Product Change Notification / JAON-19HUMO778

CCB 3676.004 and 3676.005 Final Notice: Qualification of MMT as an additional assembly site for selected MCP1725 and MCP1727 device families available in 8L DFN (2x3x0.9mm) and 8L DFN (3x3x0.9mm) packages.

**CCB 3676.004 and 3676.005
Pre and Post Change Summary
PCN#: JAON-19HUM0778**

Pre change

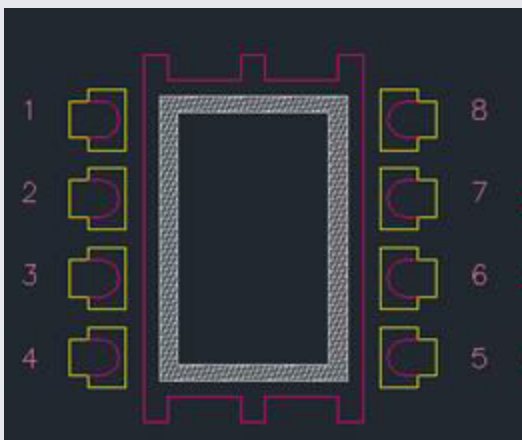
Lead frame material	EFTEC-64T
Lead frame DAP surface Prep	Ag
Lead Lock	No

Post Change

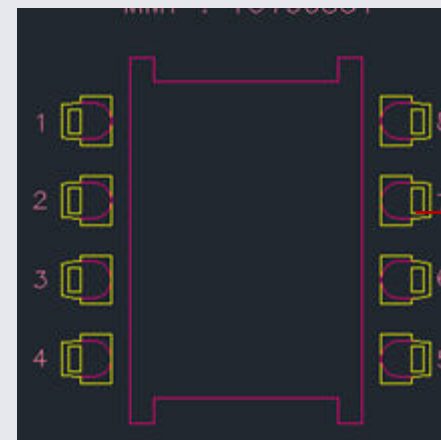
Lead frame material	C194
Lead frame DAP surface Prep	Bare Cu
Lead Lock	Yes

Note: The lead lock hole fills with mold compound during the assembly process and provides improved protection against moisture penetration around the interface edges between pins and mold compound.

Pre change

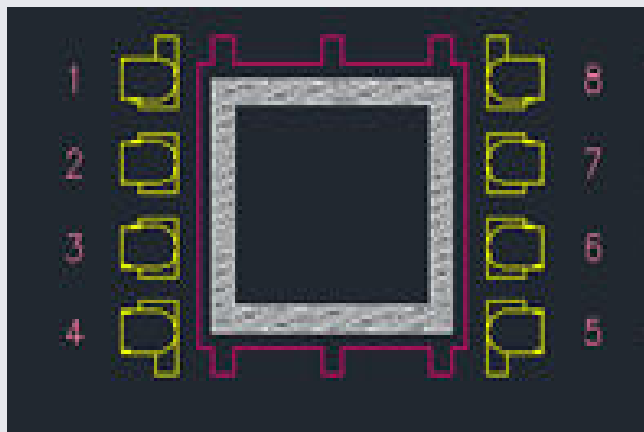
Lead frame material	EFTEC-64T
Lead frame DAP surface Prep	Ag
Lead Lock	No

Post Change

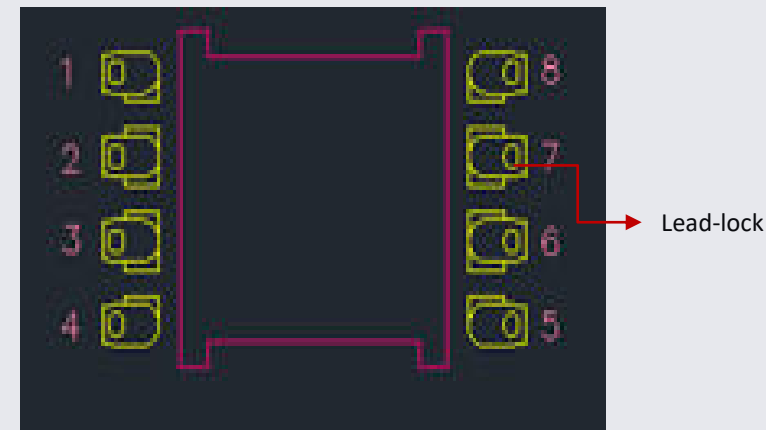
Lead frame material	C194
Lead frame DAP surface Prep	Bare Cu
Lead Lock	Yes

Note: The lead lock hole fills with mold compound during the assembly process and provides improved protection against moisture penetration around the interface edges between pins and mold compound.
